67 Kingsmark lane

**CITY OF PORTLAND, MAINE
DEVELOPMENT REVIEW APPLICATION
PLANNING DEPARTMENT PROCESSING FORM**

18 July 1995
Application Date
Stroudwater Subdivision
Project Name/Description
Kingsmark Lane (Lot #8)
Address of Proposed Site
226-A-013
Assessor's Reference: Chart-Block-Lot _____

RE: 67 Kingsmark Lane Setback Reduction

PICTURE 1

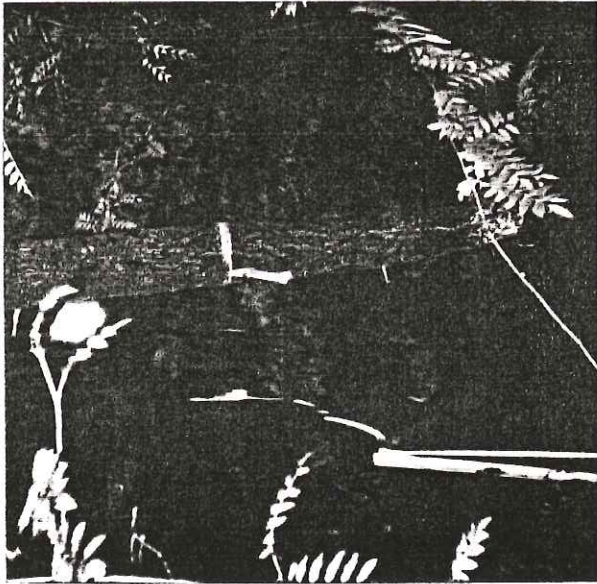
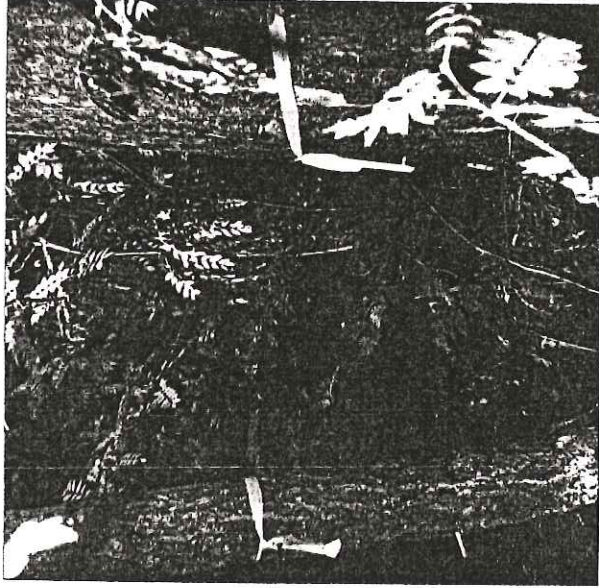
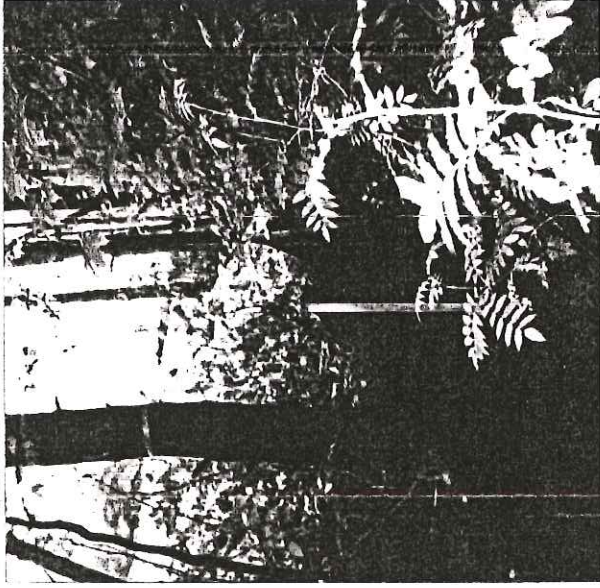
Picture taken along Protective Zone line. South orientation.

Trees with yellow surveyor's tape determined to be within Building envelope and outside Protective Zone.

Smaller tree on left is same tree as in Picture 1
